Subject: Revised Chapter 10, SNM-960 License Renewal Application

References: 1) NRC License SNM-960, Docket 70-754, TAC # L33042
2) SNM-960 License Renewal Application – D. W. Turner, 4/08/2011

Attachment: 1) SNM-960 License Renewal Application Chapter 2, Revision 2

CHAPTER 2.0
ORGANIZATION AND ADMINISTRATION

Figure 2.1
VNC Organization Chart
Key positions highlighted in yellow

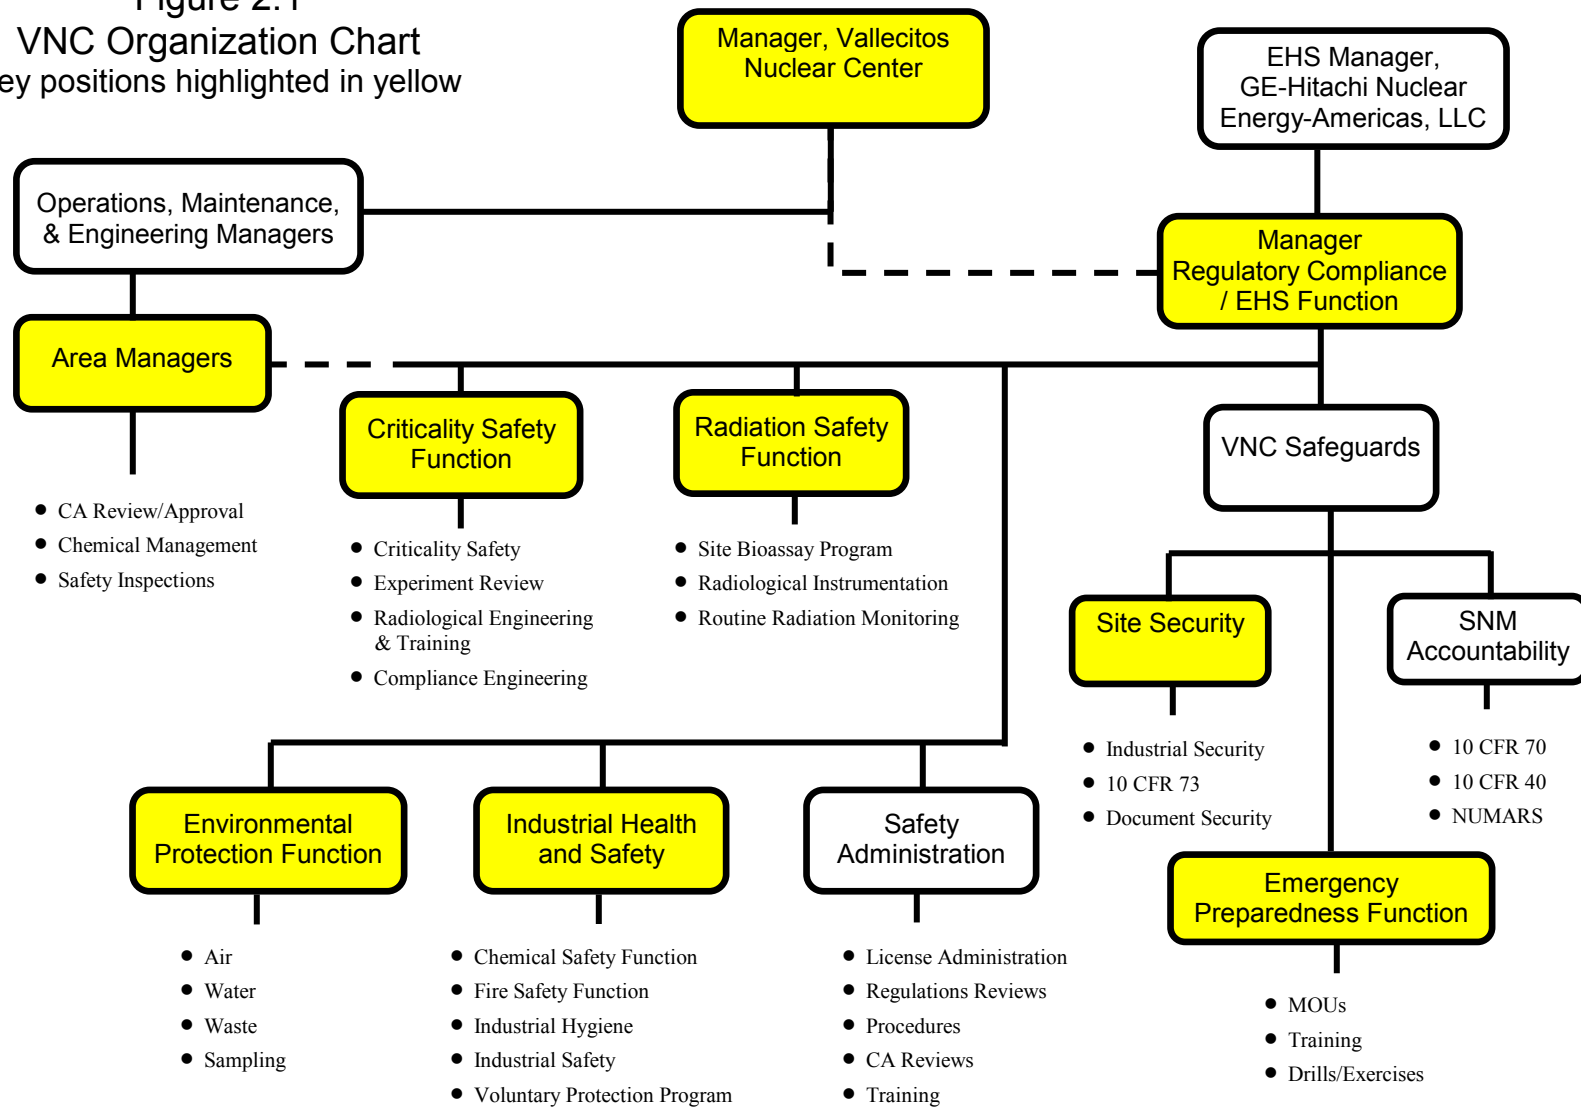
GE - Hitachi Nuclear Energy Americas LLC (GEH) hereby submits a revision to Chapter 2, "Organization and Administration", of the Vallecitos Nuclear Center SNM-960 License Renewal Application dated April 4, 2011 and submitted on April 8, 2011 (Reference 2). The reason for the change is to remove the specific type of degree required for the manager of the Regulatory Compliance Function as described on page 2.4. As a result of this change, Chapter 2 is provided as revision 2 and re-dated February 3, 2012. The change to Chapter 2 is shown with a change bar in the right hand margin of each changed page.
